UNITED STATES NUCLEAR REGULATORY COMMISSION

In the Matter of	:	
	:	Docket Nos. 50-277
PHILADELPHIA ELECTRIC COMPANY	:	50-278

APPLICATION FOR AMENDMENT
OF
FACILITY OPERATING LICENSES
DPR-44 & DPR-56

APPLICATION FOR AMENDMENT
OF
FACILITY OPERATING LICENSES
DPR-44 & DPR-56

2012 083

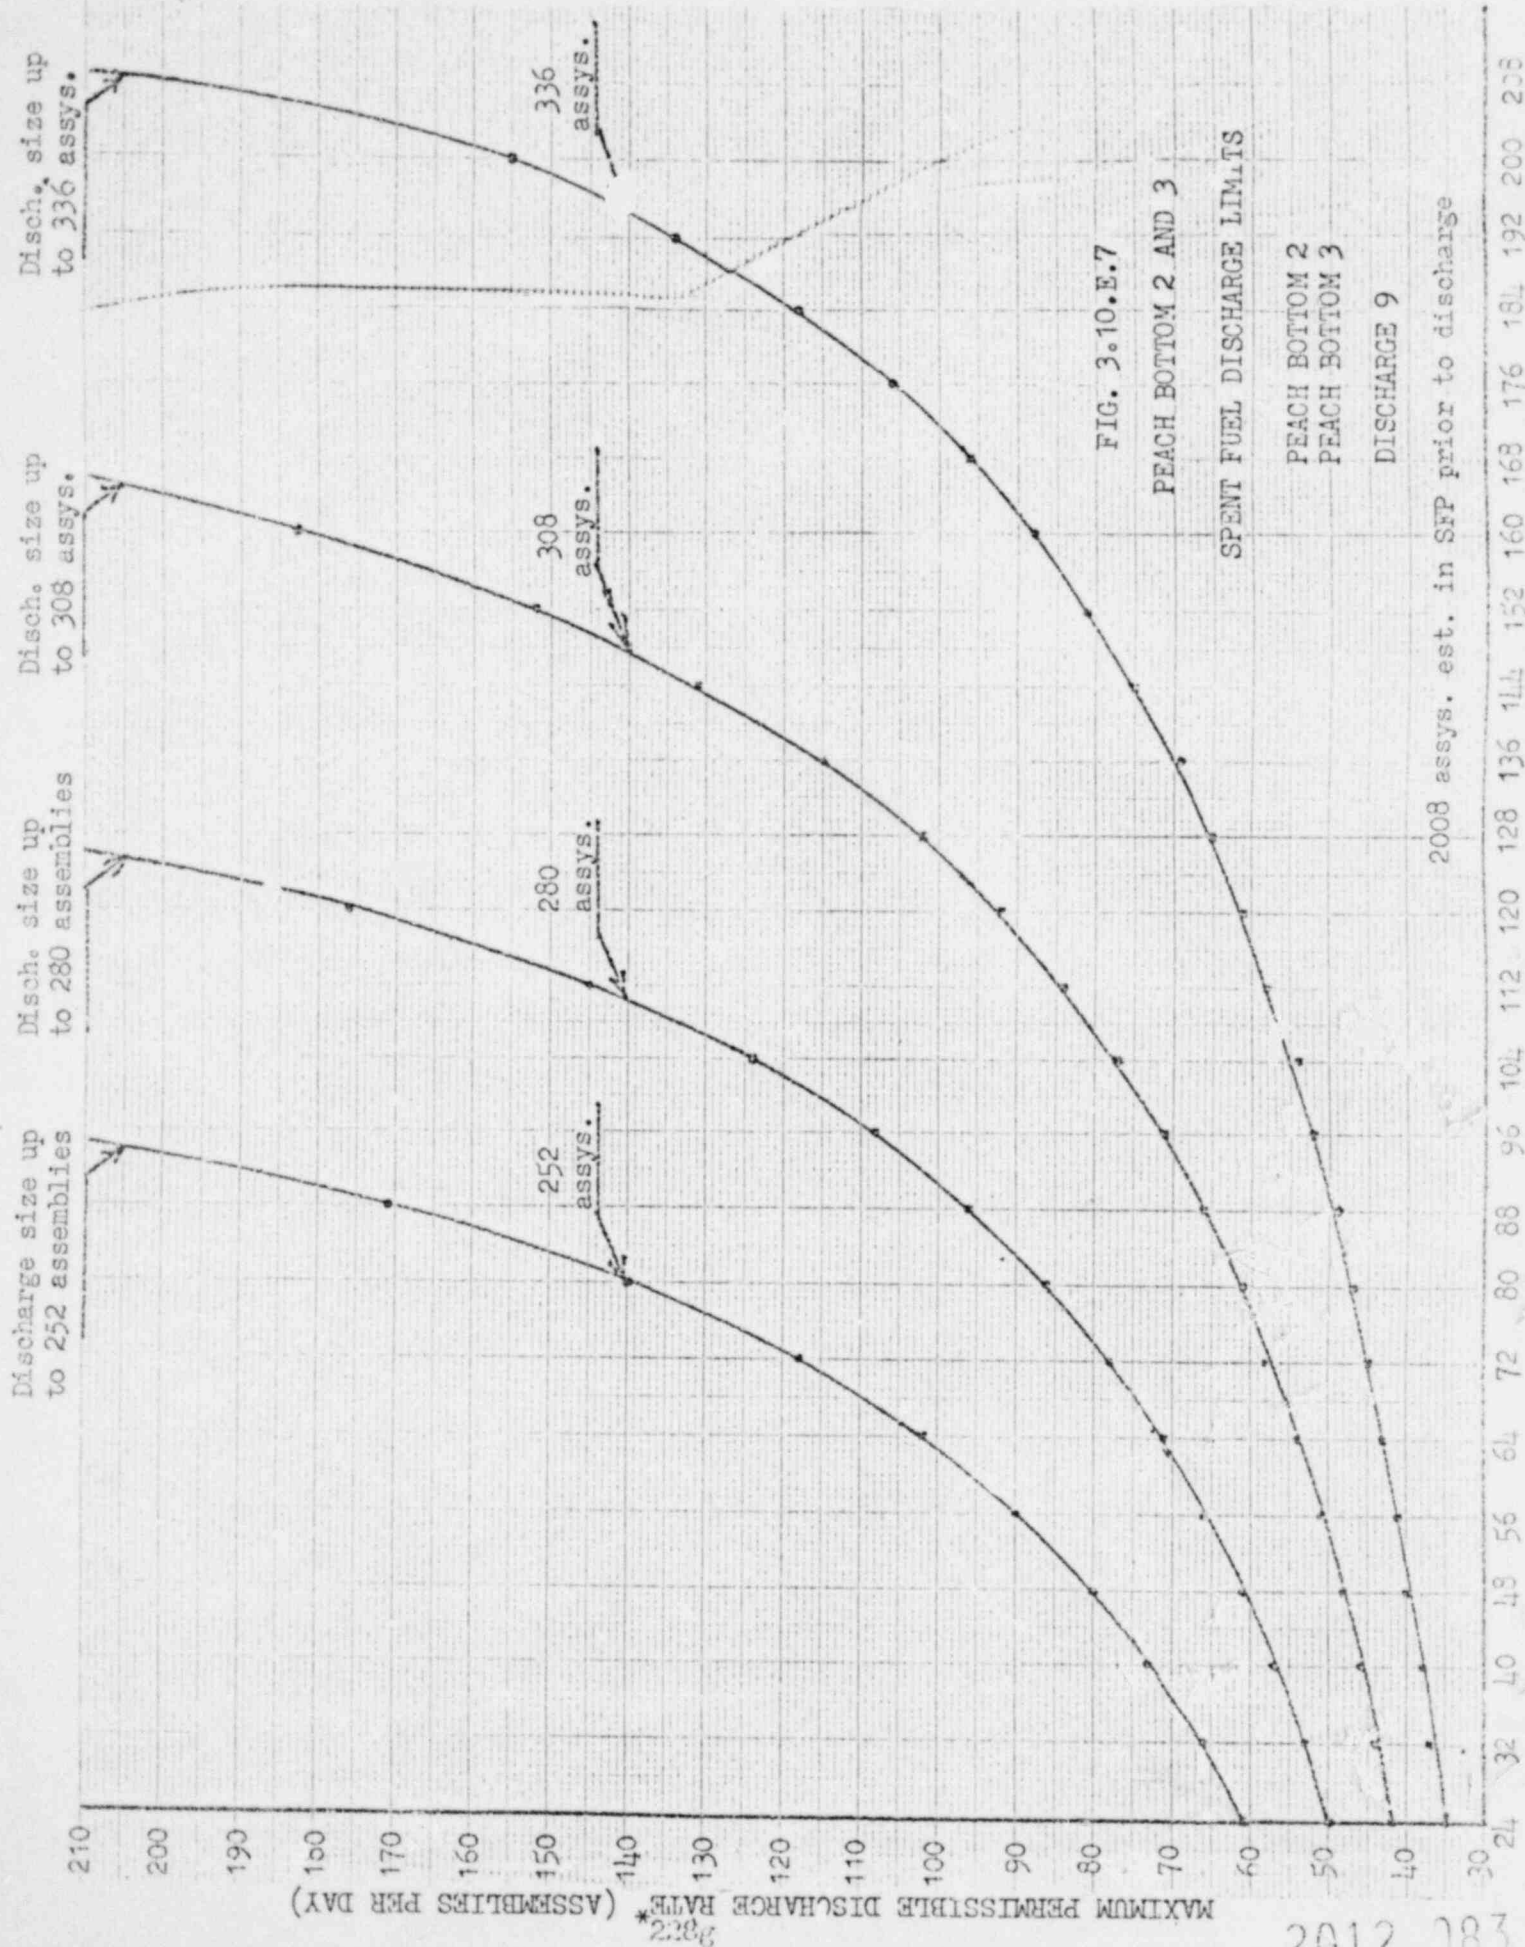
The Licensee proposes revisions to Technical Specification, section 3.10.E, that change the limiting conditions for the discharge of spent fuel from the reactor vessel to the Spent Fuel Pool. The revised limits would permit a spent fuel discharge rate based on the elapsed time following the reactor shutdown, the quantity of fuel to be discharged, river water temperature, and the discharge cycle (number). A description of the safety analysis is included in section 3.10.E BASES on page 230a. The safety analysis, using data and assumptions previously submitted on January 19, 1978, in support of the installation of high density racks in the Peach Bottom spent fuel pools, was performed to develop the maximum permissible discharge rates shown in the proposed figures 3.10.E.1 through 9.

In order to maintain SFP temperature less than or equal to 150°F, the rate of discharge of spent fuel assemblies from the reactor to the spent fuel pool shall not exceed the maximum permissible discharge rate obtained from Figures 3.10.E.1 through 9, whenever the spent fuel pool cooling system is in use. No limitations are required whenever the Residual Heat Removal System is arranged for spent fuel pool cooling.

- 1) Using the discharge (cycle) number, select the corresponding figure from Figures 3.10.E.1 through 9.
 - 2) Select the one curve (of the four in the figure selected in item 1 above) which corresponds to the discharge size next highest to (or equal to) the total number of assemblies to be moved to the SFP during the outage.

- 3) Using the time from reactor shutdown to first fuel assembly discharged (ordinate) which is achieved during the outage, read the coordinate maximum permissible discharge rate* from the curve selected in item 2) above. This maximum permissible discharge rate shall be used as a limit during the outage, in order to maintain SFP temperature less than or equal to 150°F.

- 4) If it is desired to correct the maximum permissible discharge rate for cooling (river) water temperatures, determine the river water temperature at time of first discharge and every 24 hours thereafter. Using the appropriate correction factor, multiply the maximum permissible discharge rate obtained in item (3) above by the correction factor for that 24 hour period. The corrected maximum permissible discharge rate shall be used as a limit during the corresponding 24 hour segment of the outage. Correction factors are as follows:

- a) 71°F - 80°F cooling water: 1.5
 - b) 61°F - 70°F: 2.5
 - c) 60°F or lower: 4.0
 - 5) The maximum permissible rate operates cumulatively; that is, if the permissible rate for a particular discharge is 100 assemblies per day and only 50 assemblies are discharged the first day, then 150 may be discharged the second day.

FIG. 3.10.E.8

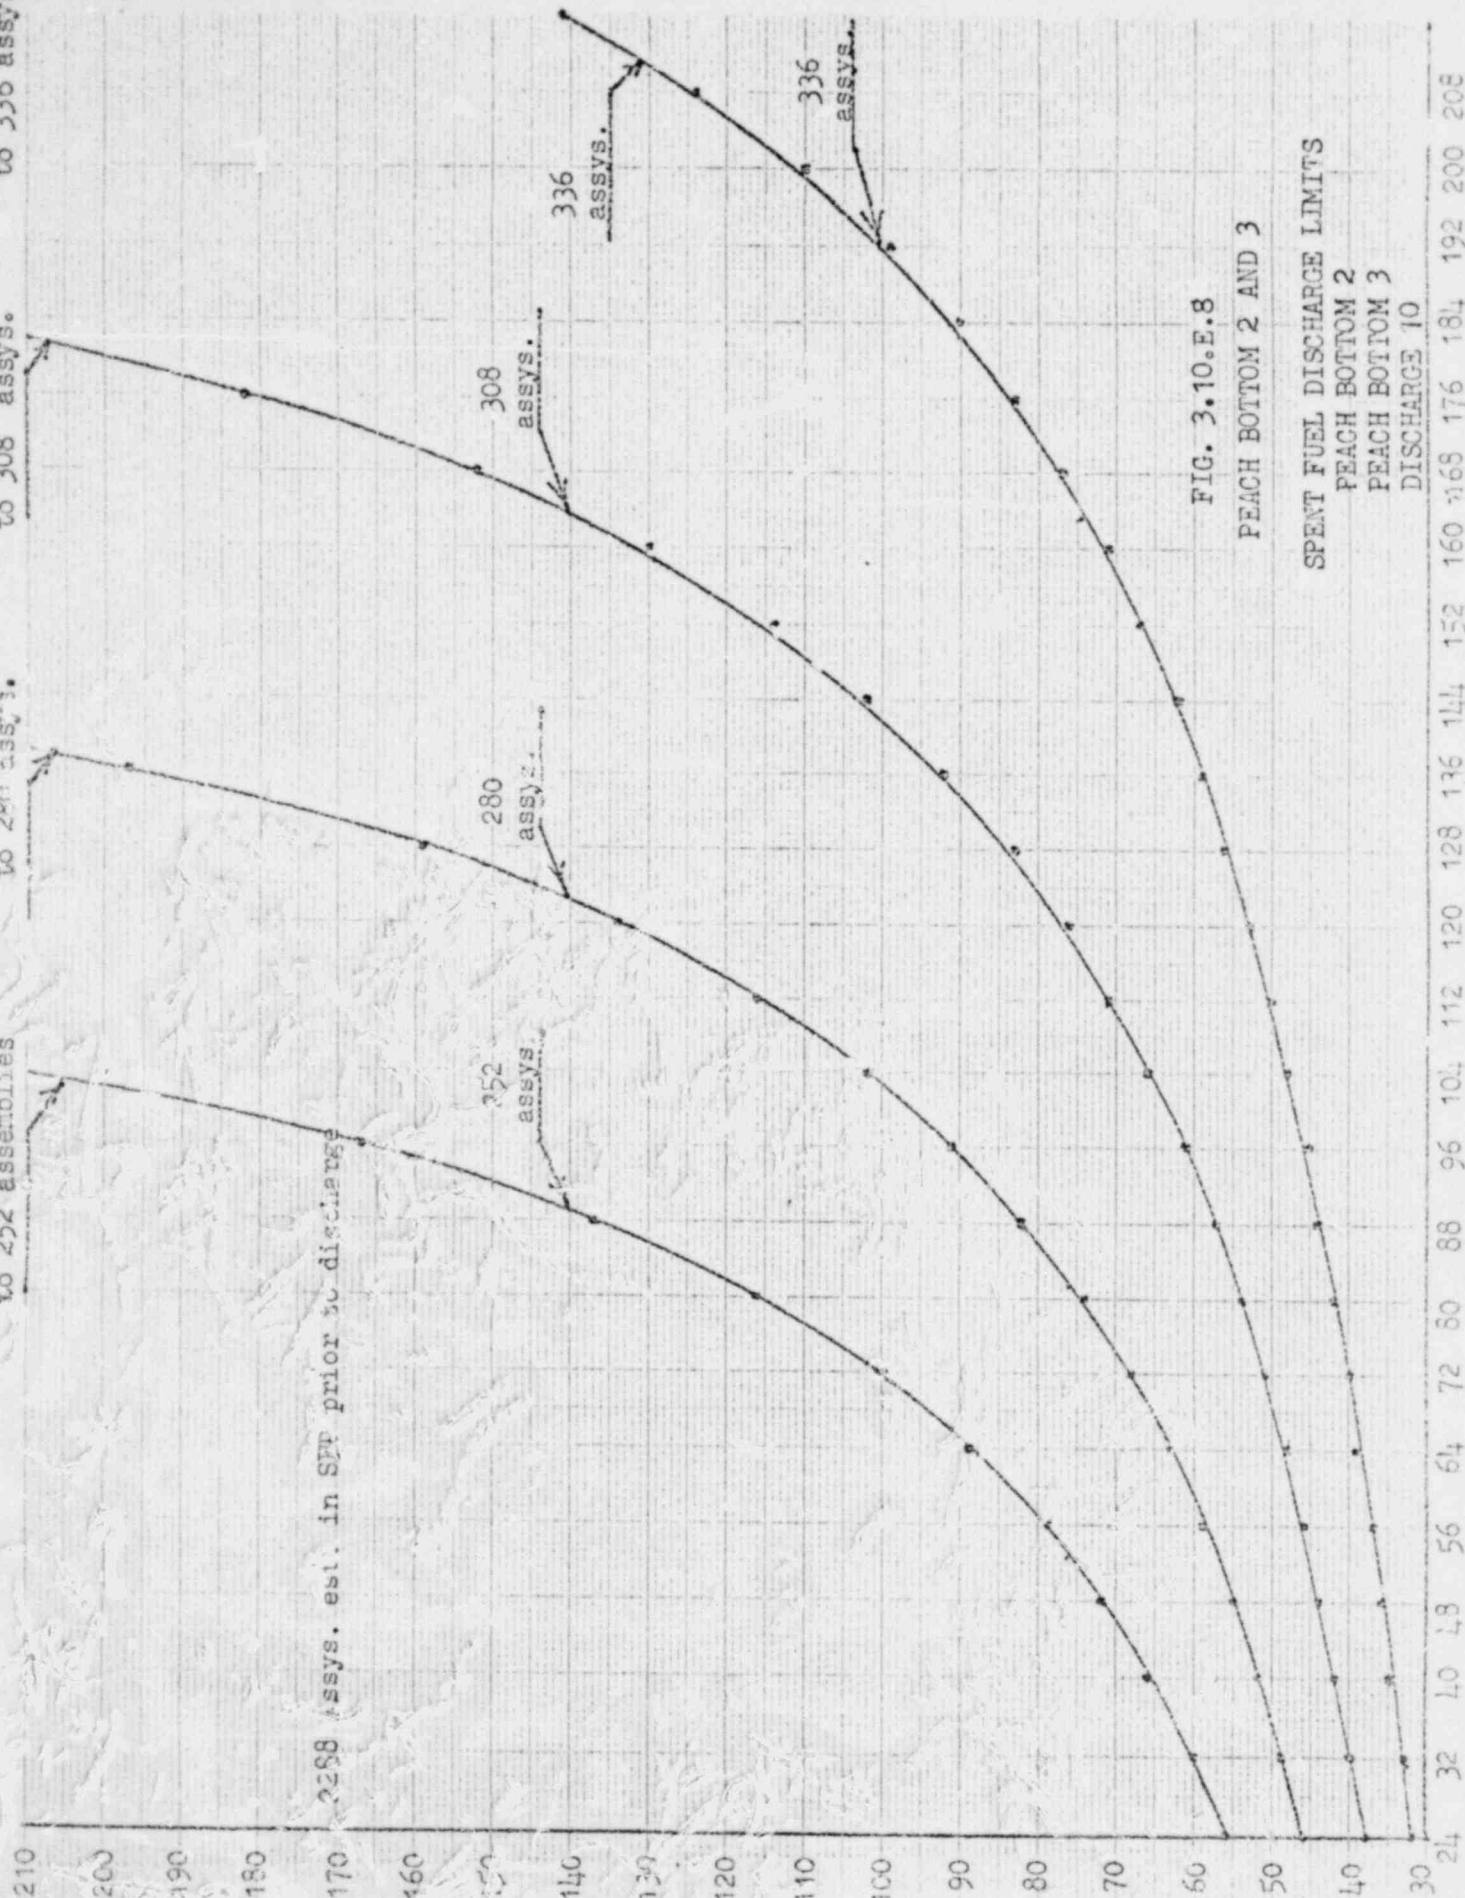
Disch. size up
to 336 assys.

Disch. size up
to 308 assys.

Disch. size up
to 280 assys.

Discharge size up
to 252 assemblies

2258 assys. est. in SFF prior to discharge

MAXIMUM PERMISSIBLE DISCHARGE RATE* (ASSEMBLIES PER MIN)

FIG. 3.10.E.9

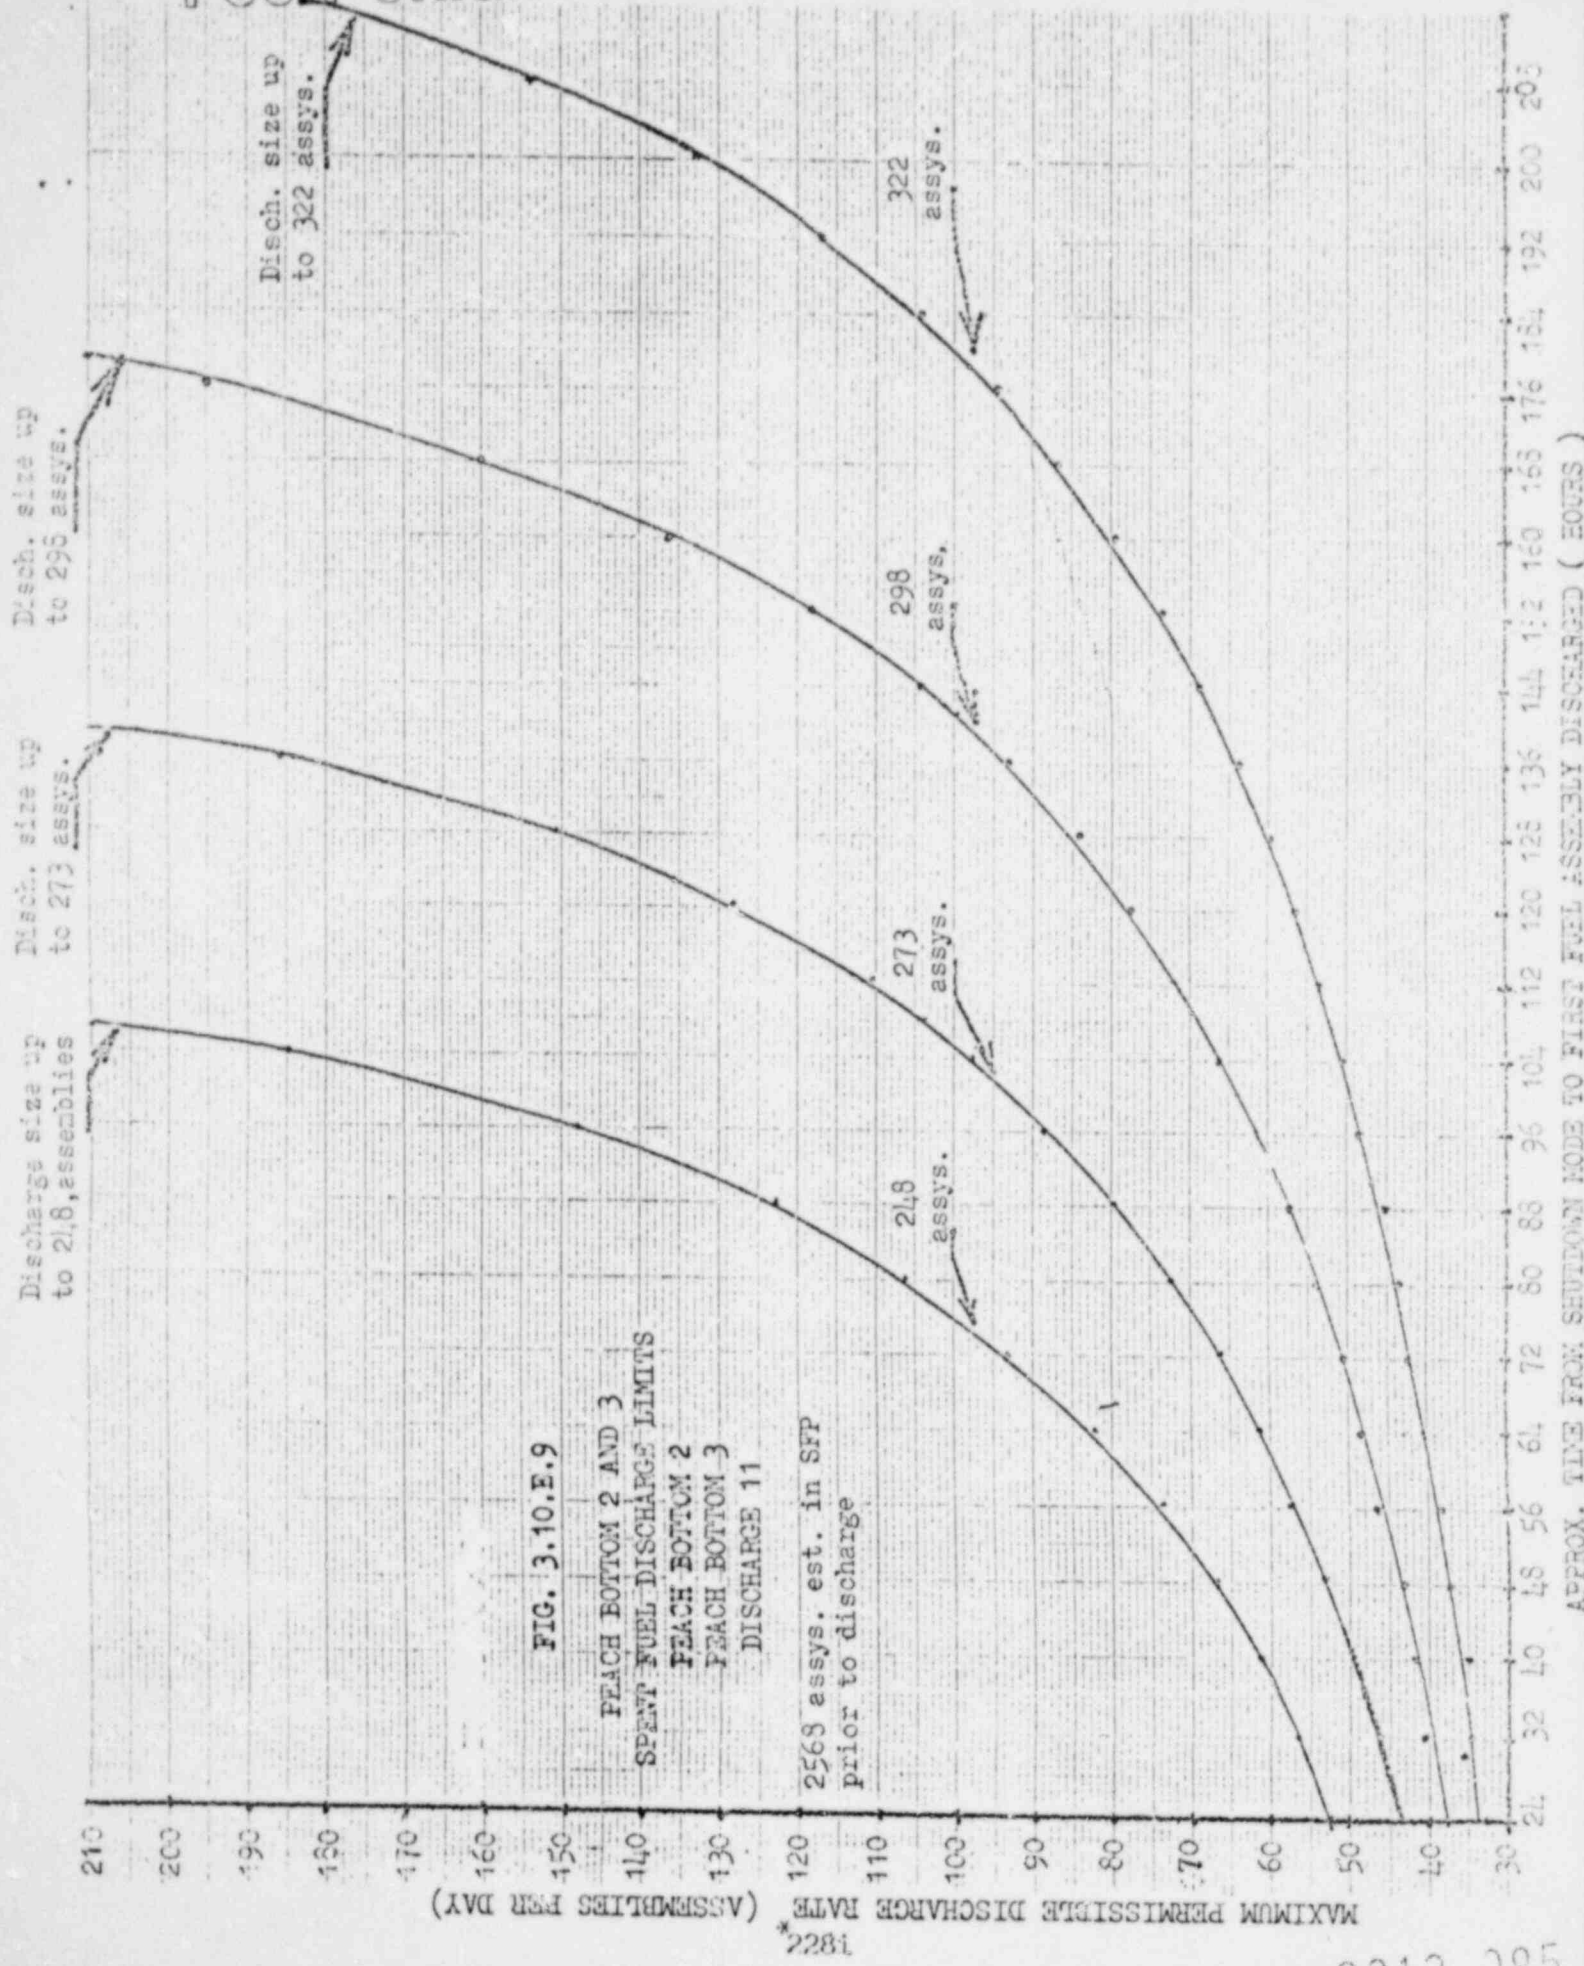
PEACH BOTTOM 2 AND 3
SPENT FUEL DISCHARGE LIMITS
PEACH BOTTOM 2
PEACH BOTTOM 3
DISCHARGE 11

2568 assys. est. in SFP
prior to discharge
